UNITED STATES PATENT AND TRADEMARK OFFICE

10/578,421

Office Action Summary	Application No. 10/578,421	Applicant(s) KANG ET AL.	
	Examiner Dinesh Vesra	Art Unit 3633

DETAILED ACTION

Fig. 4***Claim Rejections - 35 USC § 103***

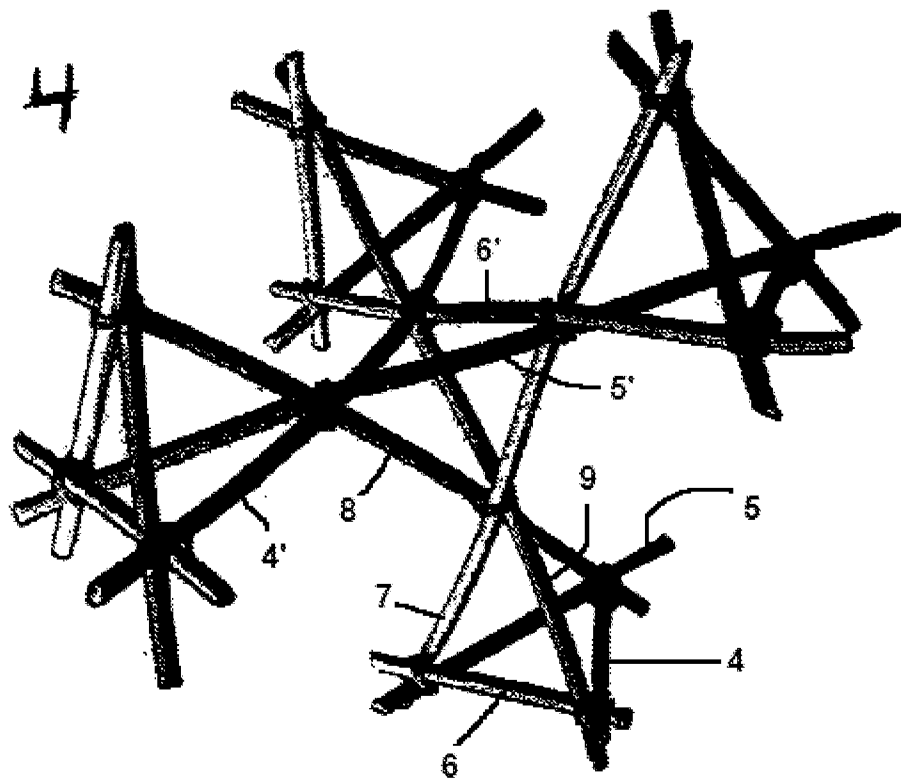
5. **Claims 1-6 are rejected under 35 U.S.C. 102(b) as being clearly anticipated by Snelson (US Patent Application Publication 2002/0081936 A1).** Snelson discloses a three-dimensional wire-woven cellular light structure (see Fig. 4 below) formed of six groups of orientational-continuous-wires intercrossed with each other at 60 degrees or 120 degrees of angles in a three-dimensional space, a unit cell of the cellular light structure comprising: a first regular tetrahedron member formed of a first to sixth wires, the first regular tetrahedron member being constructed in a such a manner that the first wire (4), the second wire (5), and the third wire (6) are intercrossed in a plane to form an equilateral triangle, the fourth wire (7) is intercrossed with the

intersection point of the second wire (5) and the third wire (6), the fifth wire (8) is intercrossed with the intersection point of the first wire (4) and the second wire (5), and the sixth wire (9) is intercrossed with the intersection point of the third wire (6) and the first wire (4), the fourth wire (7), the fifth wire (8), and the sixth wire (9) being intercrossed with one another at a single reference intersection point; and a second regular tetrahedron member contacted with the first regular tetrahedron member at the reference intersection point and having a similar shape to the first regular tetrahedron member, the second regular tetrahedron member being constructed in such a manner that the fourth wire (7), the fifth wire (8), and the sixth wire (9) pass the reference intersection point and extend further, each of a group of wires (4', 5', and 6') is intercrossed with the two wires selected from the extended fourth, fifth and sixth wires, the group of wires (4', 5' and 6') being in parallel with the first wire (4), the second wire (5), and the third wire (6) respectively; wherein the wires are intercrossed with each other at 60 degrees or 120 degrees, and the unit cell is repeated in a three-dimensional pattern, thereby forming a truss-type structure (though the reference does not specifically teach these angles, it does teach that the structures are tetrahedral, which inherently form these angles); wherein among the six groups of orientational-wires, three groups of orientational-wires forming a vertex of the first or second regular tetrahedron member are intercrossed clockwise or counterclockwise when seen from the front of the vertex (see Fig. 4); wherein the first and second regular tetrahedron members have a similarity ratio of 1:1 (see Fig. 4); wherein the first and second regular tetrahedron member have a ratio of similarity in the range of 1:1 to 1:10 (see Fig. 4);

wherein the wires are any one selected from the group consisting of metal, ceramics, synthetic resin, and fiber-reinforced synthetic resin (Paragraph 0034); and wherein the intersection point of the wires is bonded by any one selected from the group consisting of a liquid- or spray-form adhesive, brazing, soldering, and welding (Paragraph 0046).
